Board Report

**PLANNING AND PROGRAMMING COMMITTEE
OCTOBER 14, 2020****SUBJECT: LOS ANGELES UNION STATION FORECOURT AND ESPLANADE
IMPROVEMENTS****ACTION: APPROVE RECOMMENDATION****RECOMMENDATION**

APPROVE the Addendum No. 2 to the Final Environmental Impact Report for the Los Angeles Union Station Forecourt and Esplanade Improvements Project.

**RE: SC# 2016121064 Los Angeles Union Station Forecourt & Esplanade
Improvements Project, EIR Addendum #2**

1. Adjustments to Shade Cover:

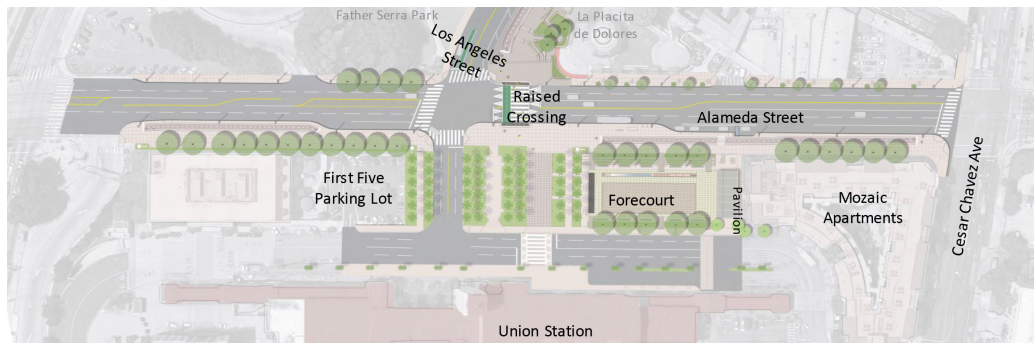
The 2015 Union Station Master Plan ("Transforming Union Station") presented a vision for the improved pedestrian experience in accessing Union Station from Alameda Street. This plan called for the installation of new double-rows of mature sidewalk trees providing shade cover from midday sun. The plan showed 76 mature sidewalk trees located in double-rows to enhance the pedestrian experience, aesthetics, and usability of these sidewalks on hot days.

As climate change continues to impact Southern California, Los Angeles residents and visitors are increasingly becoming familiar with 100°+ Fahrenheit days for longer periods and more regularly throughout the year. At these temperatures, it is absolutely critical to provide the relief of shade cover for people not enclosed in air-conditioned vehicles, including pedestrians, bicyclists, and people with disabilities on whom the project is focused.

With adjustments to the proposed roadway configuration of Alameda Street, Metro is now proposing to eliminate 50 of the originally planned 76 Alameda sycamore or similar shade trees (a reduction of 28 from the 54 trees on Alameda referenced in the adopted 2018 FEIR). Additionally, the revised plan shows 17 more trees relocated away from the center of the sidewalk to the edge of the Metro property line. These combined changes in reduction and relocation of shade trees result in a significant reduction in the amount of shade cover provided to pedestrians and bicyclists in accessing Union Station.
